# Product Update Announcement

Effective: 10-13-2020

## MAGNUM KEYPAD CHANGES

*Improving our products - Latest Version 10.3*

### Ver. 10.3 - Gasket added

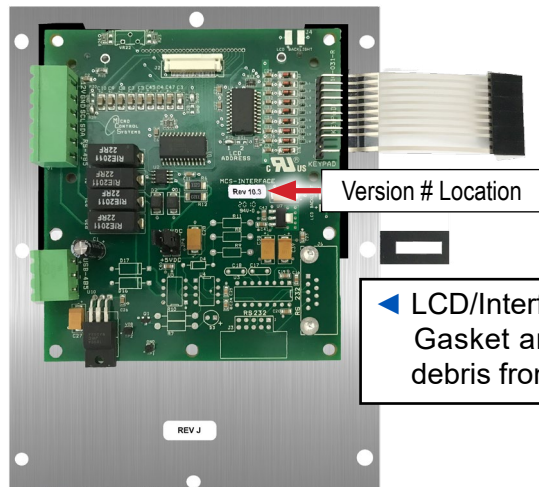
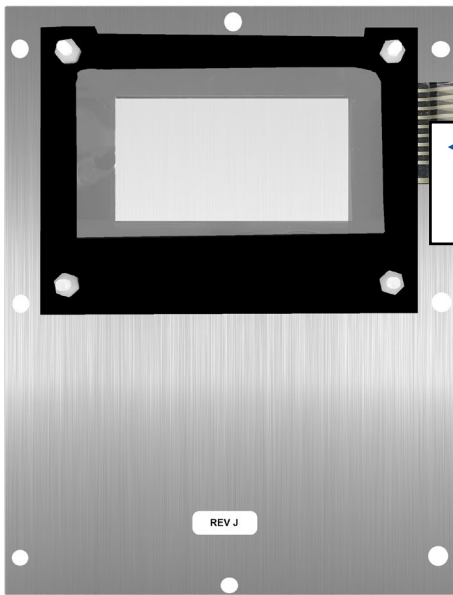
◀ On the new Mag-Keypads (Interface 10.3) we have added a Gasket between the Keypad and the LCD/Interface board to prevent debris from entering.

◀ LCD/Interface board added over Gasket and sealed to prevent debris from entering.
